**ADDENDUM NO. 01**

**GREATER BINGHAMTON AIRPORT**

**Rehabilitation of Hangars 2&3 – Phase 2**

**M-J PROJECT NO.: 01.19090.06**

PL101A

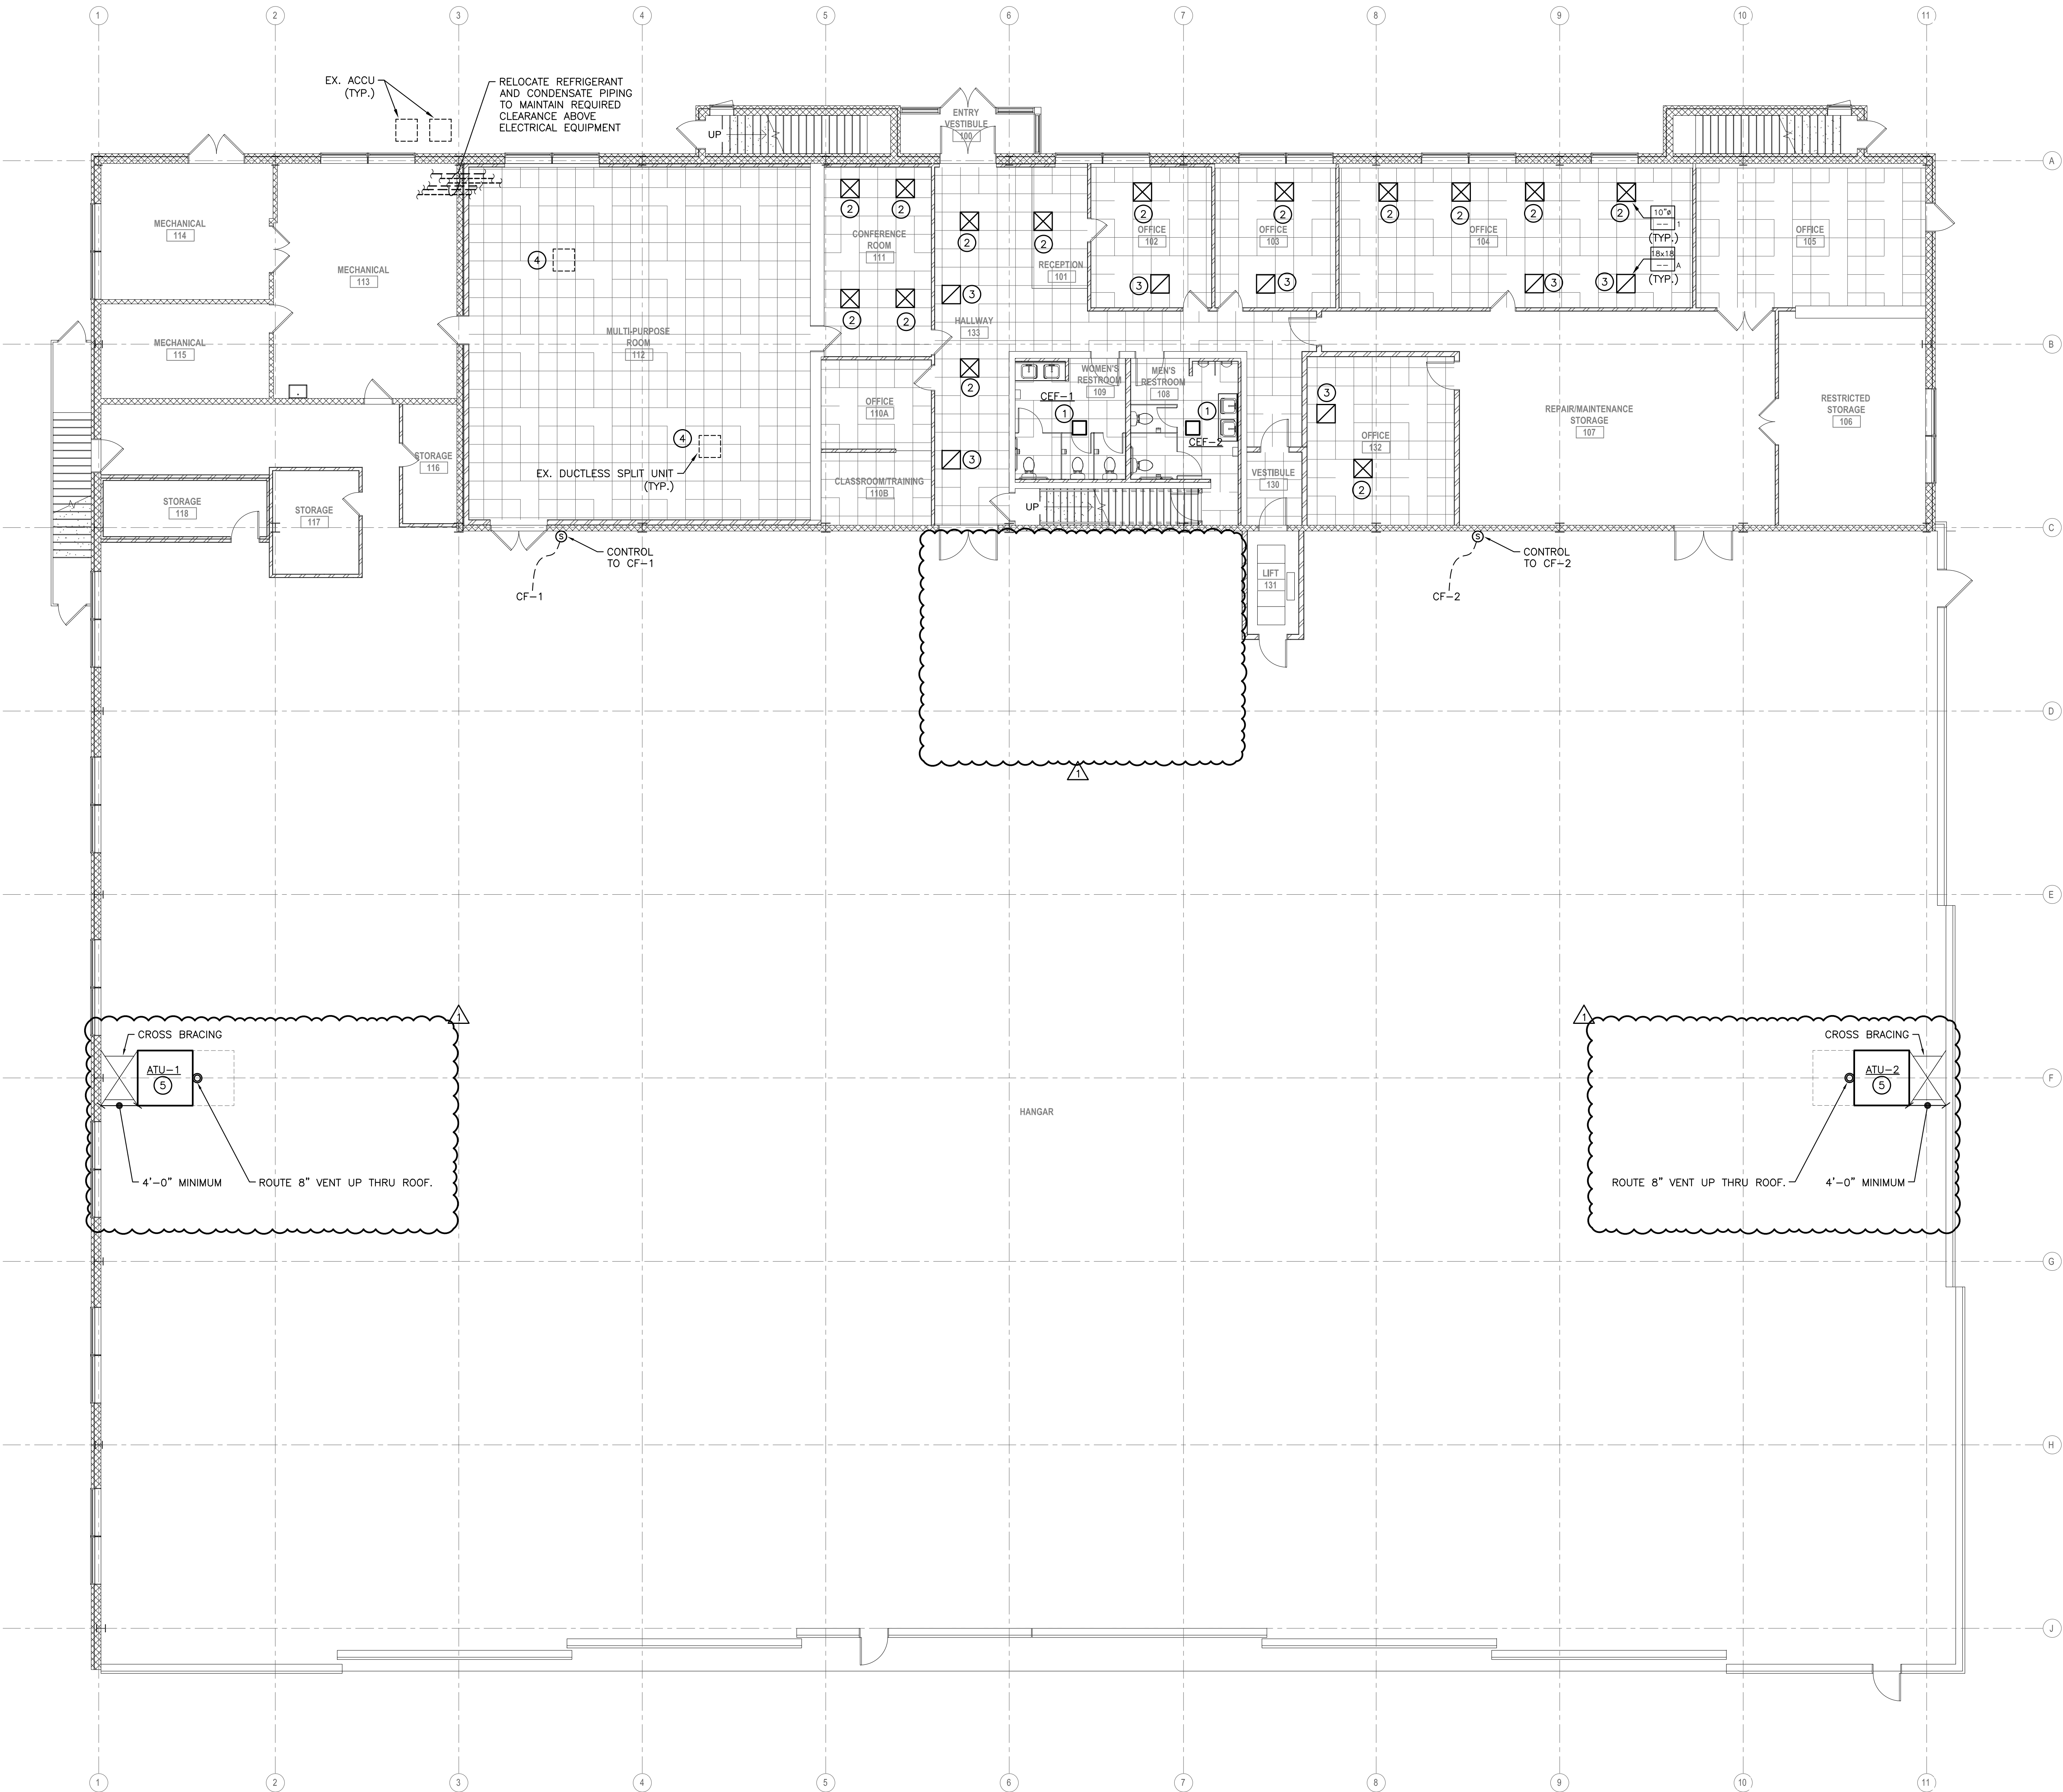
REPLACE Drawing PL101 in its entirety with the attached Drawing PL101A (Changed location of ATU)

DRAWING NUMBER  
MH101A  
04 OF 09

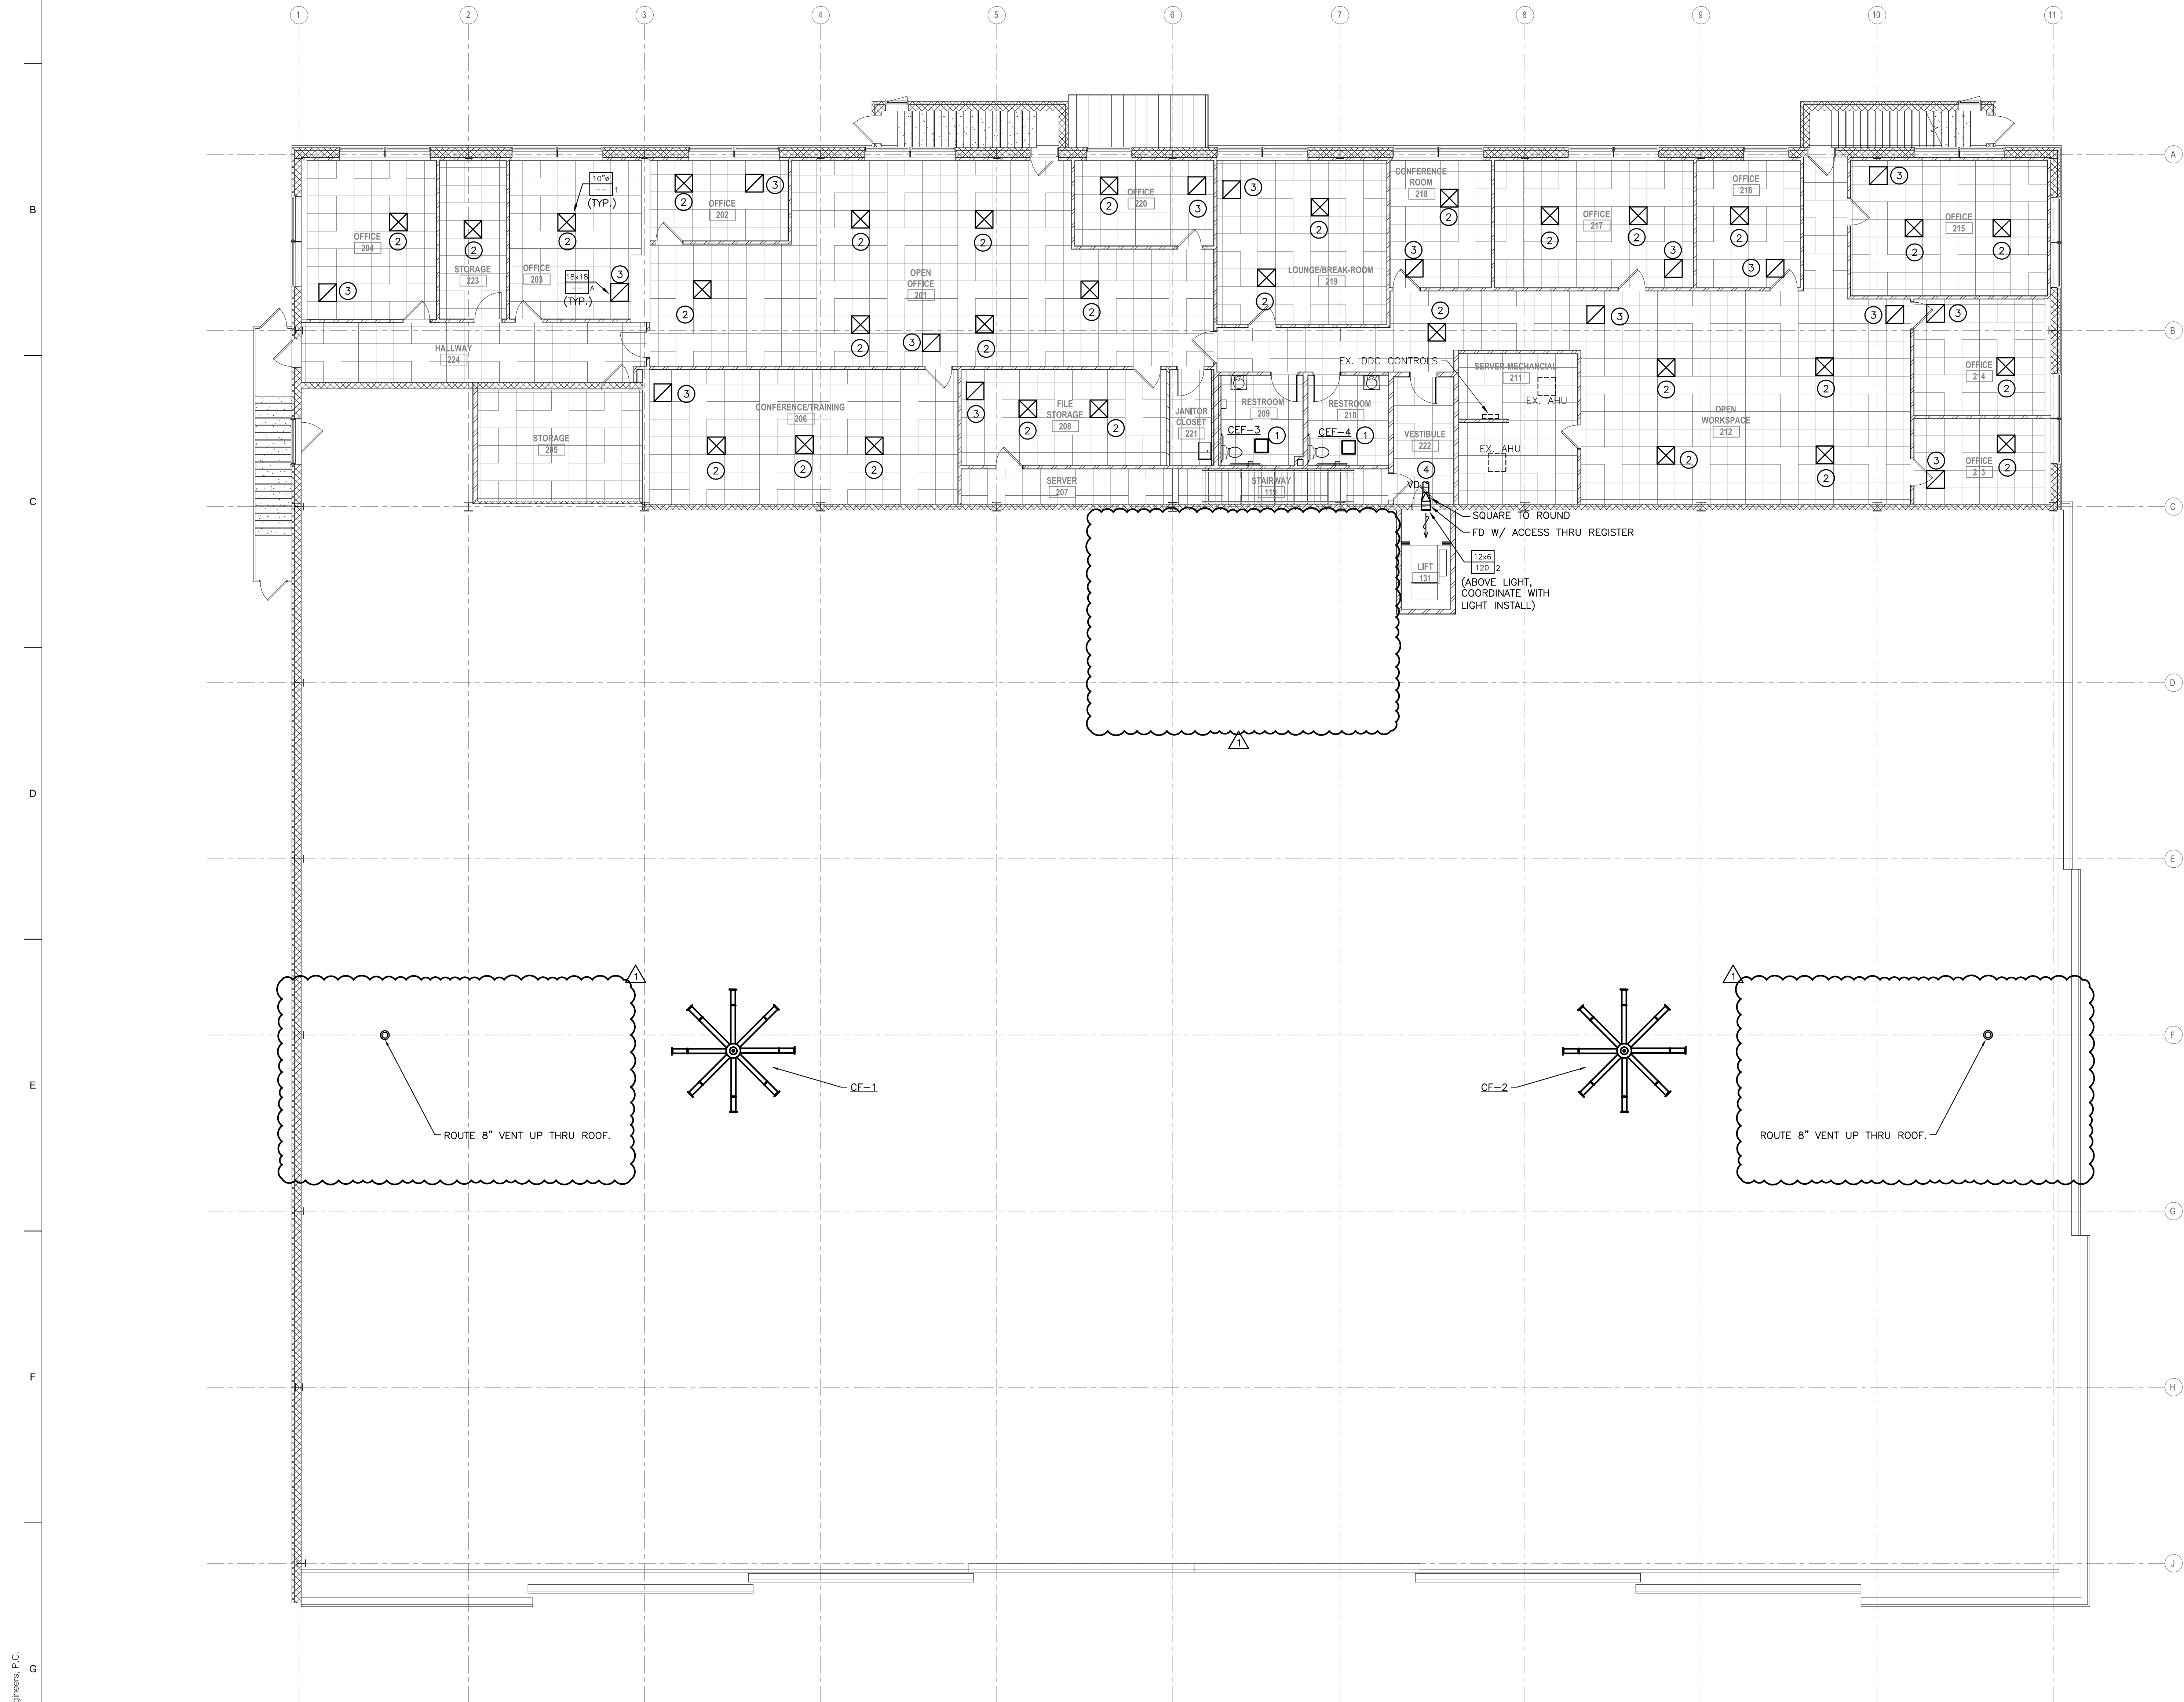
REPLACE Drawing MH101 in its entirety with the attached Drawing MH101A  
(Changed location of ATU)
- (13) Drawing MH102- Hangar 2 Second Floor Plan – Mechanical

MH601A

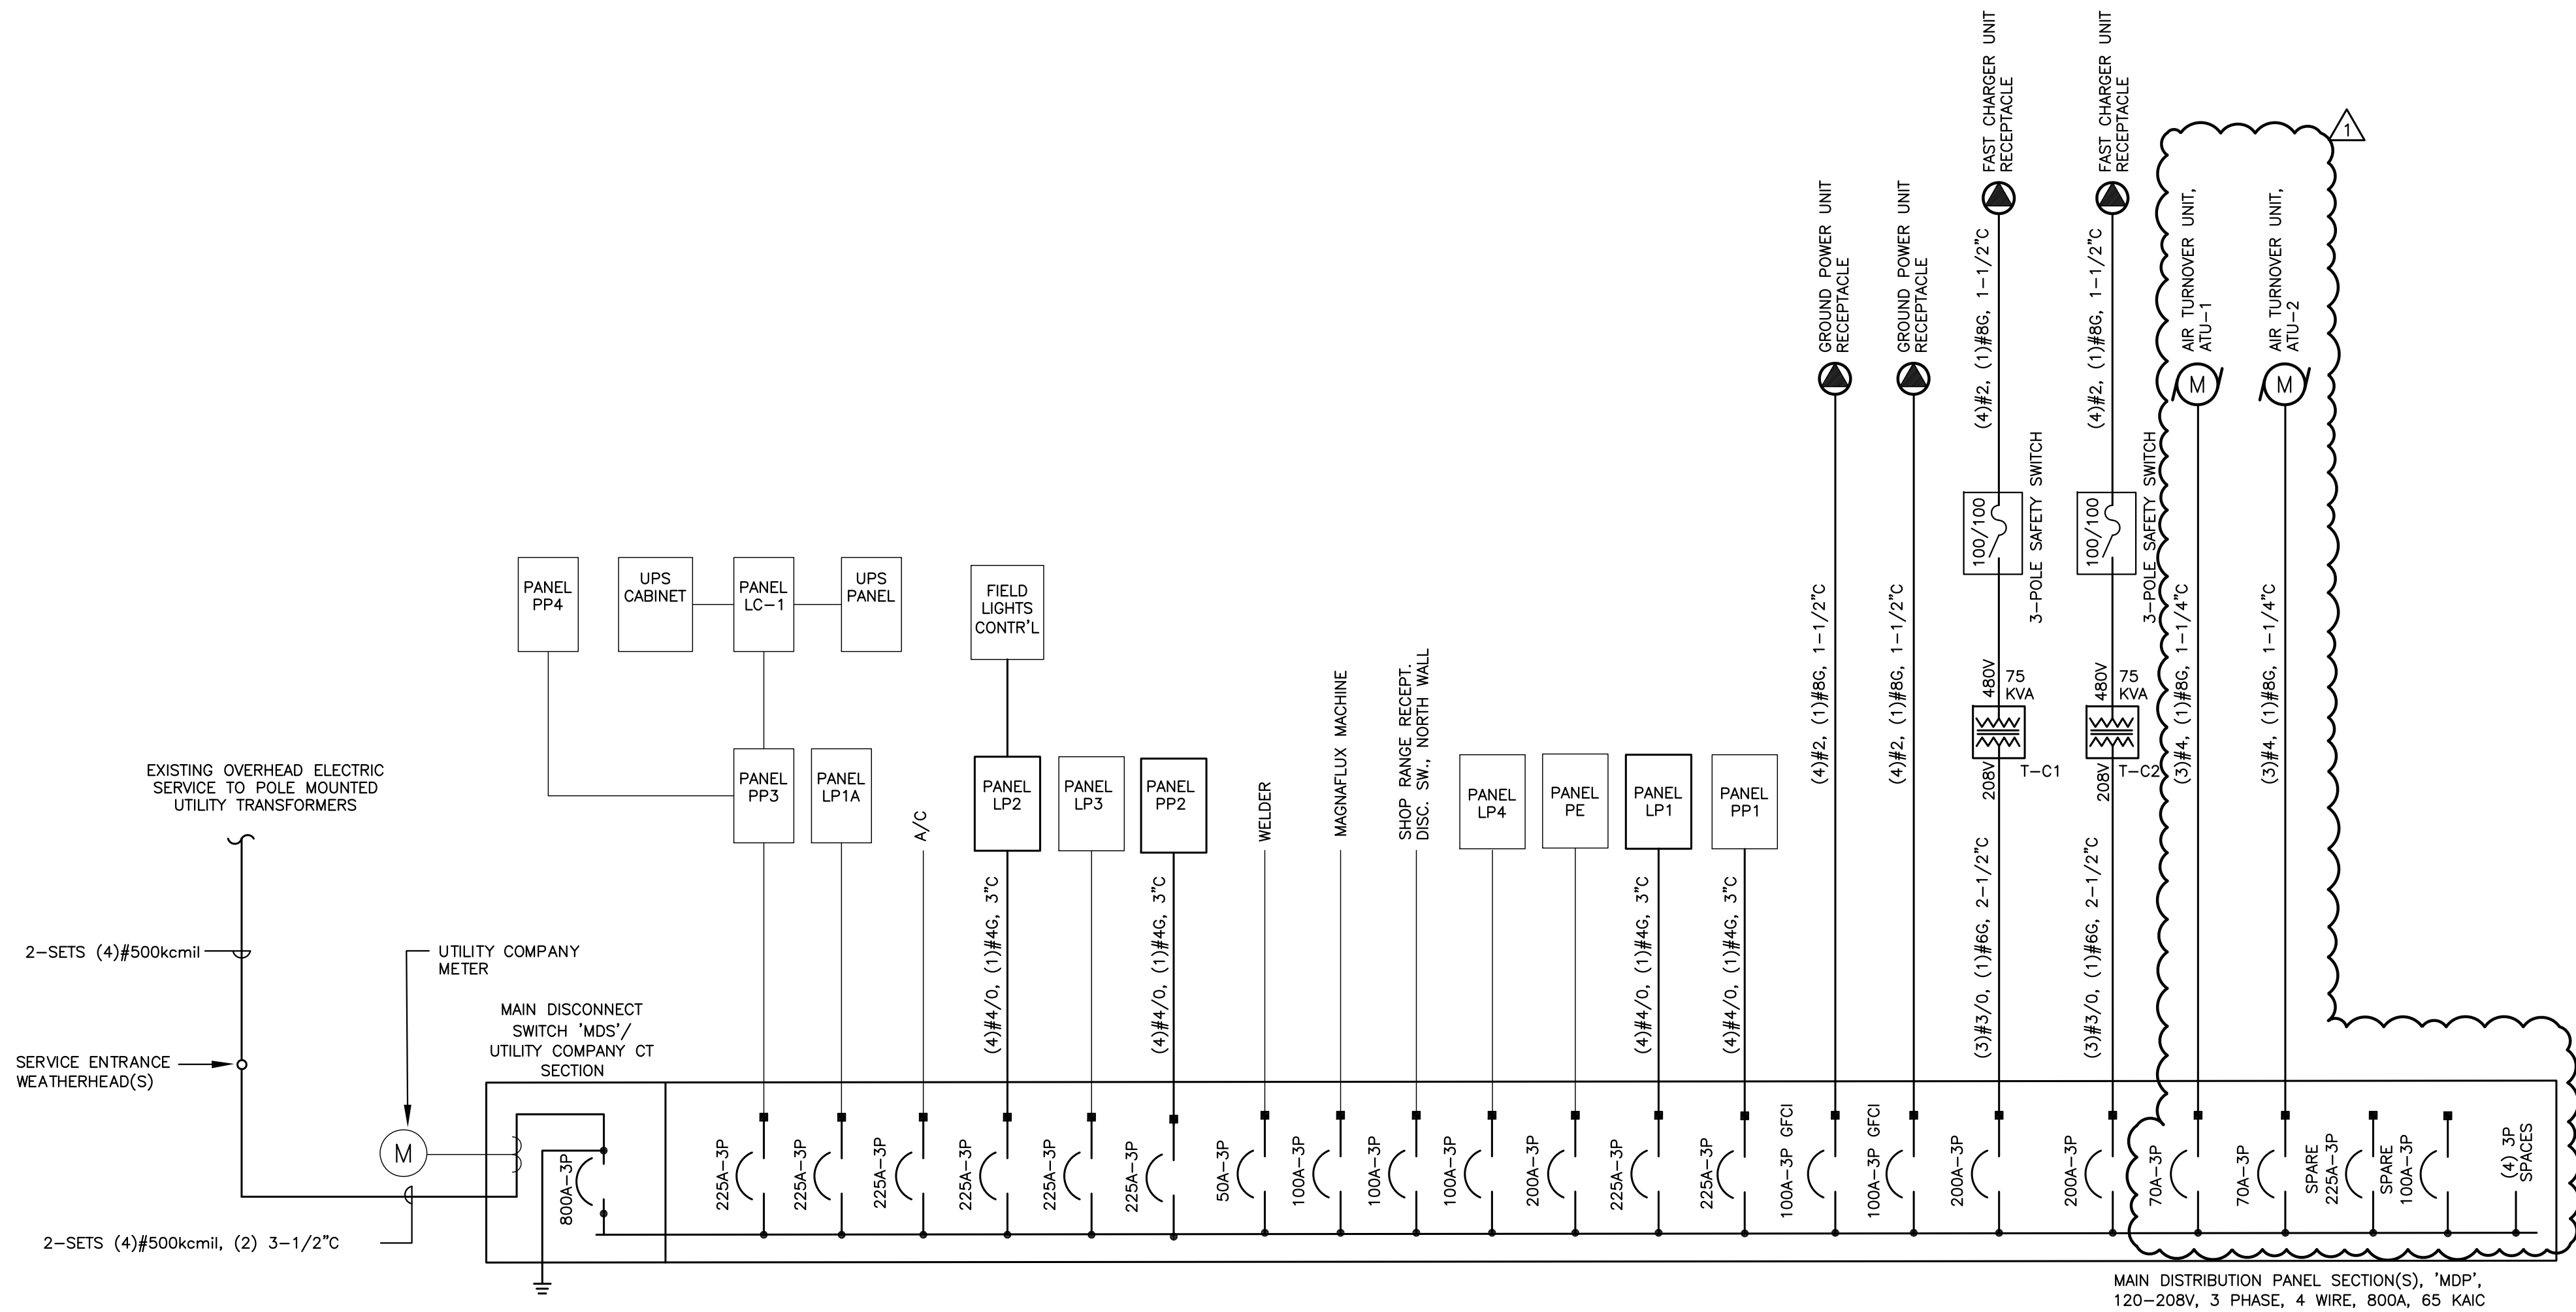
REPLACE Drawing MH601 in its entirety with the attached Drawing MH601A  
(Updated Air Turnover Unit Schedule)
- (15) Drawing EP101- Hangar 2 first floor plan – Power and Fire Alarm
